RS-13-177

Limerick Generating Station, Units 1 and 2
Facility Operating License Nos. NPF-39 and NPF-85
NRC Docket Nos. 50-352 and 50-353

Subject: Response to Request for Additional Information - Overall Integrated Plan in Response to Commission Order Modifying License Requirements for Reliable Spent Fuel Pool Instrumentation (Order No. EA-12-051)

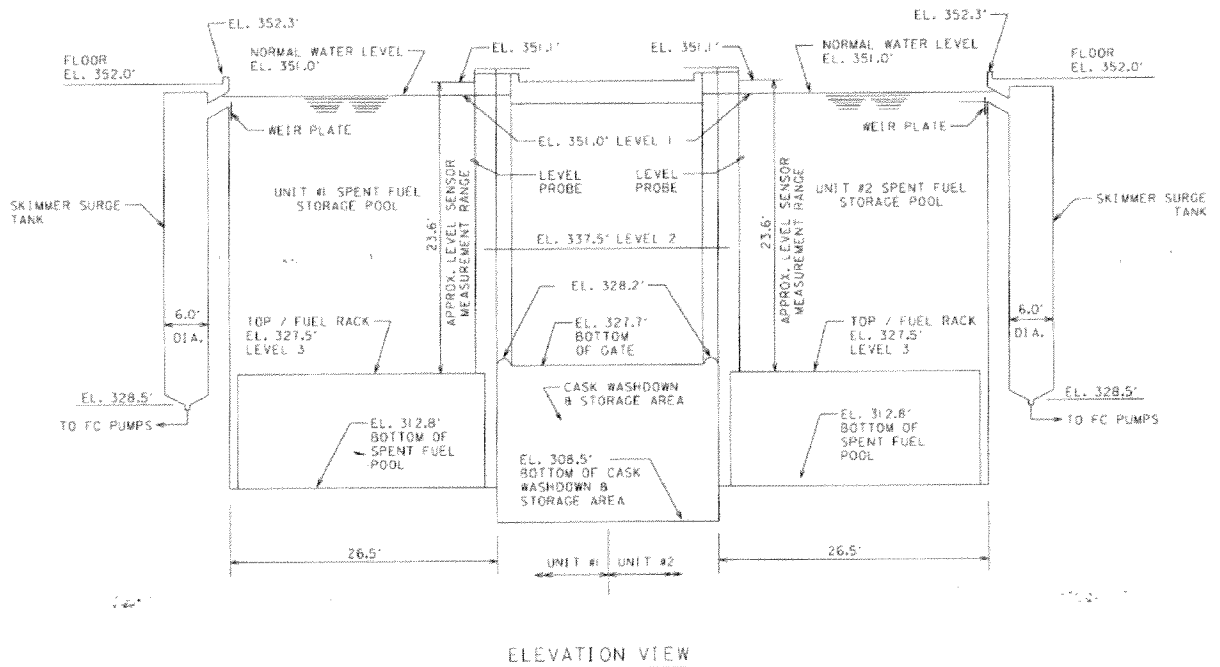
- a) For level 1, specify how the identified location represents the HIGHER of the two points described in the NEI 12-02 guidance for this level.
- b) A clearly labeled sketch depicting the elevation view of the proposed typical mounting arrangement for the portions of instrument channel consisting of permanent measurement channel equipment (e.g., fixed level sensors and/or stilling wells, and mounting brackets). Indicate on this sketch the datum values representing Level 1, Level 2, and Level 3, as well as the top of the fuel racks. Indicate on this sketch the portion of the level sensor measurement range that is sensitive to measurement of the fuel pool level, with respect to the Level 1, Level 2, and Level 3 datum points. Indicate on this sketch the elevation of the bottom opening of the gates that connect the two pools.

- a) The Spent Fuel Pool at Limerick Generating Station has wave suppression scuppers located at the 351'-0" elevation that water must flow into. From there the water is routed to the surge tanks from which the Fuel Pool Cooling (FC) Pumps draw suction. The suction trip is at an approximate 344' elevation. Thus, the 351'-0" elevation reflects the higher of the two points noted in NEI 12-02, Section 2.3.1.
- b) Please reference the sketch below. The response to instrument probe mounting details in the Spent Fuel Pool area will be provided in accordance with the response to RAI-3.
